# USE ON REVIEW REPORT

► **FILE #:** 9-A-21-UR

**9-A-21-UR  
USE ON REVIEW**

Contractor's office and storage yard in PC (Planned Commercial) (k)

**2 SITE PLAN**  
 MAGNETIC NORTH  
 A101 SCALE: 1" = 40'-0"

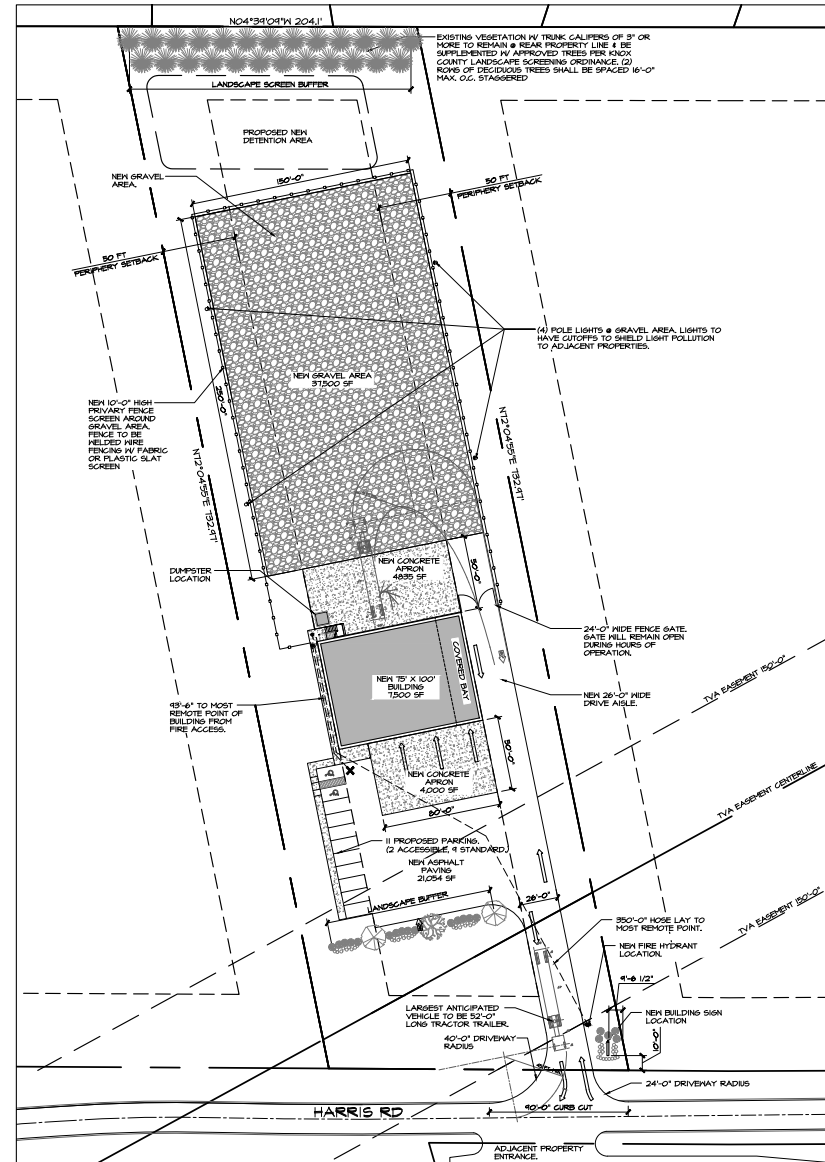
1. Storage areas for materials and equipment. **(37,500 sqft outdoor storage area to the rear of the site.)**
2. Parking and maintenance areas for business vehicles. **(Maintenance will be performed in the building and storage of business vehicles will be in the outdoor storage area.)**

3. Location of all buildings and structures on the site. **(Provided. See site plan)**
4. Vehicular and pedestrian circulation on the site, including points of access to the site from a public road, loading and unloading areas, and areas for employee and customer parking. **(Provided. See site plan.)**

5. Required or proposed landscaping and buffer areas. **(Type A landscape screen will be provided along the rear property line per the zoning condition placed on the property by Knox County Commission and a Type C landscape screening along the south side of the parking area according to the landscape screening standards of Article 4, Section 4.10.11.)**

6. Required or proposed screening and fencing of storage yards. **(A 10'-0" tall welded wire fence w/ fabric mesh screen or plastic slats will be installed around the gravel area.)**

5. *Setback of storage areas.* All storage areas associated with the contractor storage yard shall be no less than twenty-five (25) feet from any property line. **(The proposed setback is 25-ft to the side property lines and greater to the other property lines.)**

6. *Storage yard screening and fencing.* Equipment, parking facilities and material storage areas must be screened from adjoining properties as established on the site plan. **(A 10-ft tall opaque fence is proposed as well as landscape screening to the rear of the property.)**

**A501**

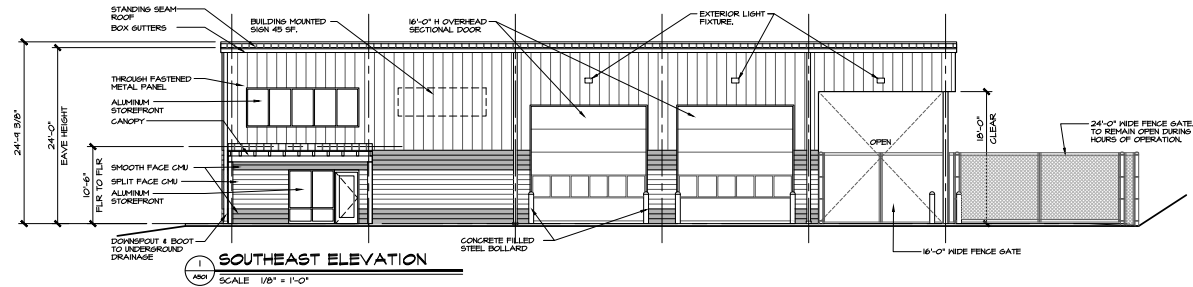
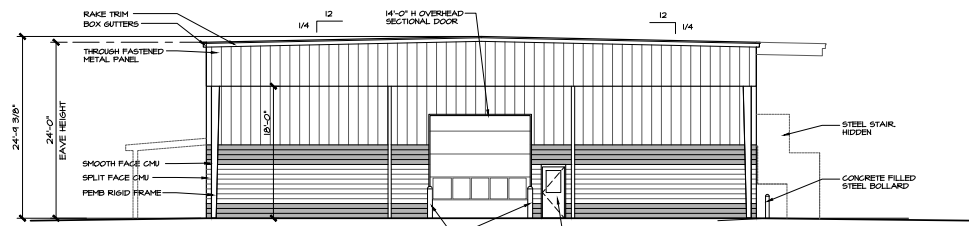
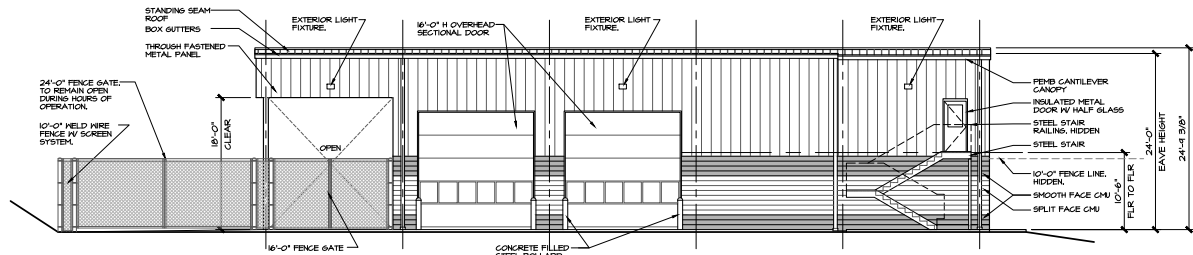
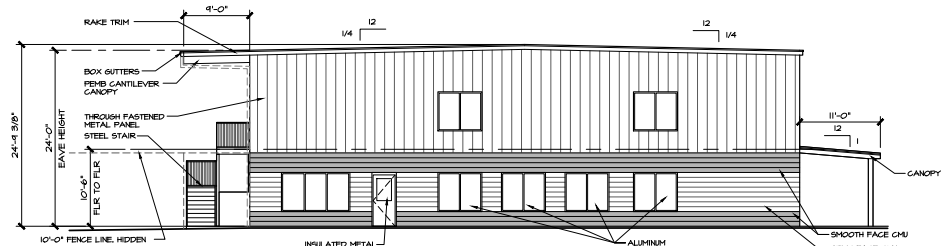
D. The size of the proposed structure is similar to an office building but the exterior will have industrial look. To help soften the appearance of the structure, the exterior will be a combination of smooth-faced CMU and split-faced CMU at the base of the building, and metal panels on the upper portion (see sheet A501).
